## **Proposal to correct ECE/TRANS/WP.29/GRE/2010/53**

Note: The text reproduced below was prepared by the expert from the International Electrotechnical Commission (IEC) in order to correct data on light source categories D5S and D6S, as proposed by GTB to GRE in document GRE/2010/53. The modifications to the current text of Regulation No. 99 are marked in bold characters.

IEC has reviewed proposal ECE/TRANS/WP.29/GRE/2010/53 and propose the following corrections:

Figure 1 - Category D5S - Cap PK32d-[7]

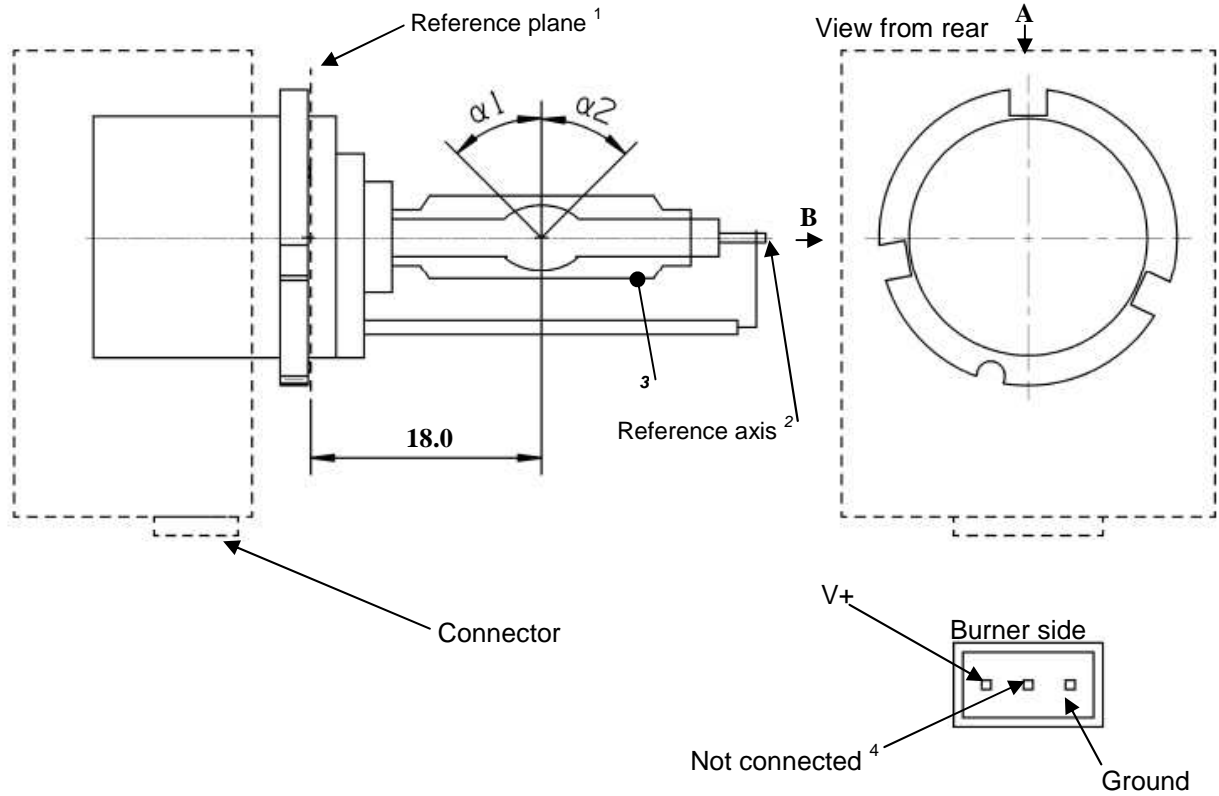
#### **2. Page 5, Sheet D5S/1**

- Revise **Figure 1 - Category D5S - Cap PK32d-[7]** to better reflect the IEC cap description
- Insert a new note 4 "<sup>4</sup> **Optional Pin**"

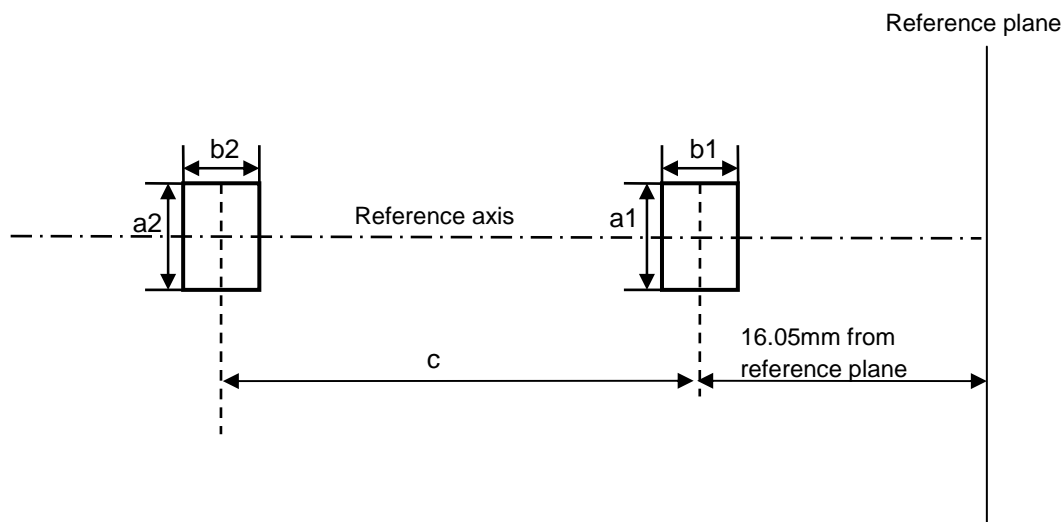
#### **3. Page 7, table**

- Colour boundaries: remove border lines partially to express x,y coordinates form a pair
- Cap key number: put in brackets as in name of figure 1 page 5, similar to IEC sheet number

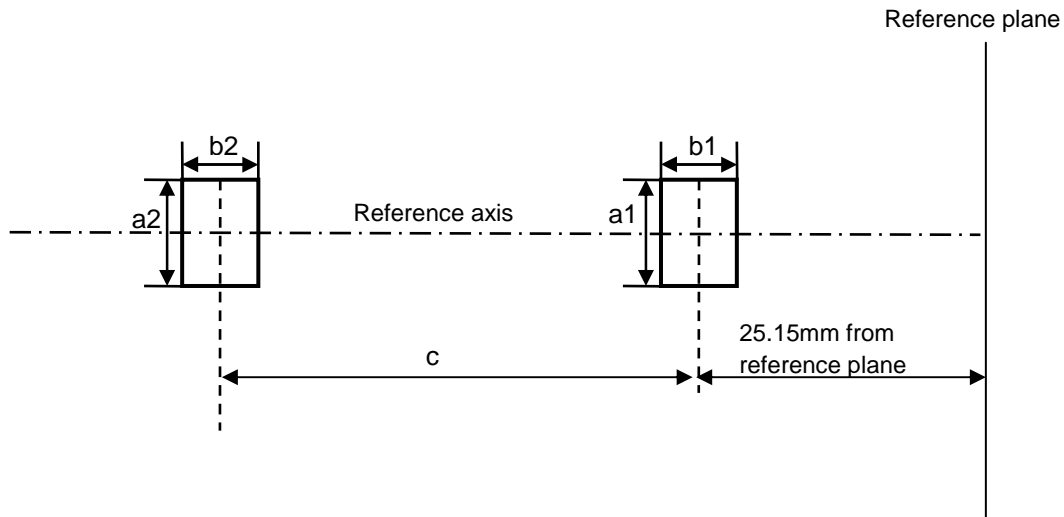
#### **5. Page 12, table**

- Colour boundaries: remove border lines partially to express x,y coordinates form a pair
